Enclosure 2. Conforming Amendments to Facility Licenses Nos.: DPR-1, TR-1, R-33, DR-10

UNITED STATES  
NUCLEAR REGULATORY COMMISSION  
WASHINGTON, DC 20555 - 0001

GENERAL ELECTRIC COMPANY

AMENDMENT TO FACILITY LICENSE

Figure 6-1. Facility Organization

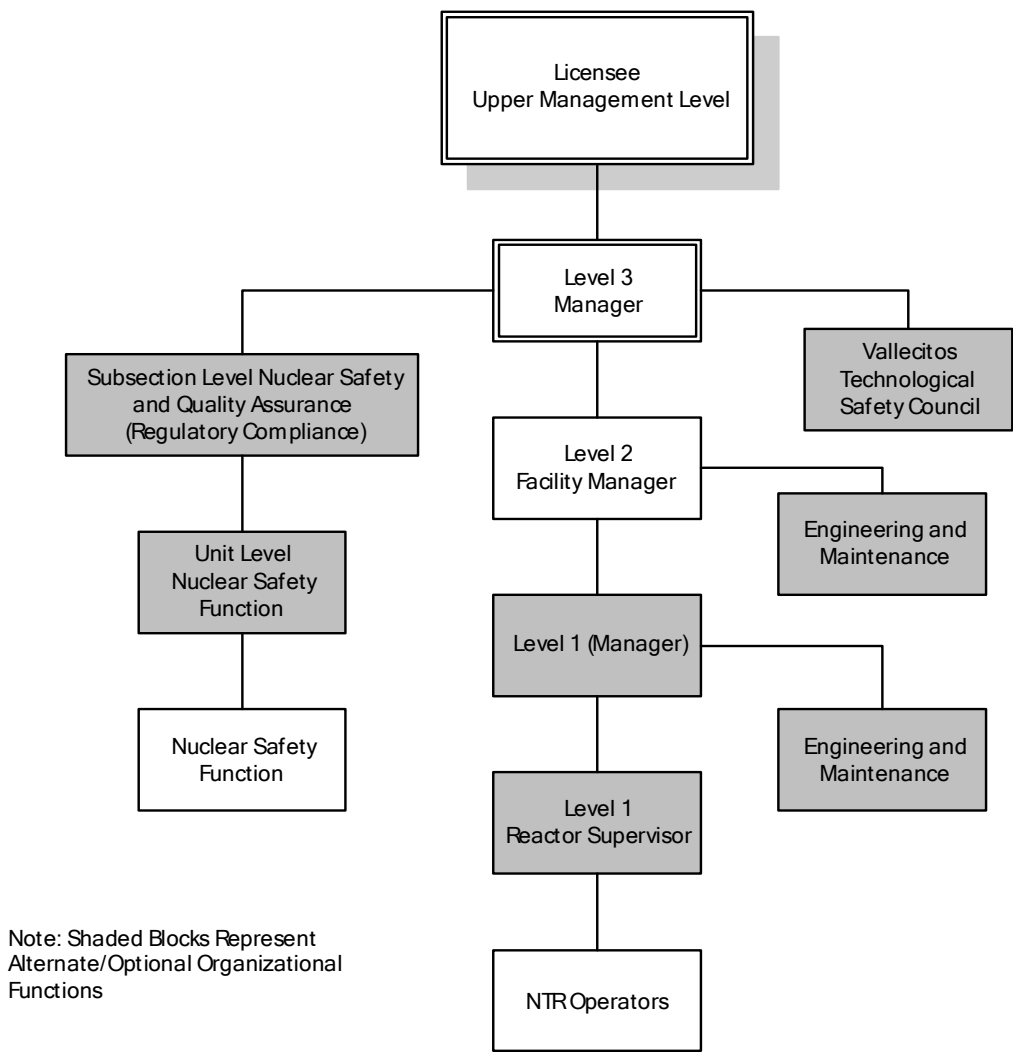
The NTR shall be owned and operated by the licensee with management and operations organization as shown in Figure 6-I or equivalent. |
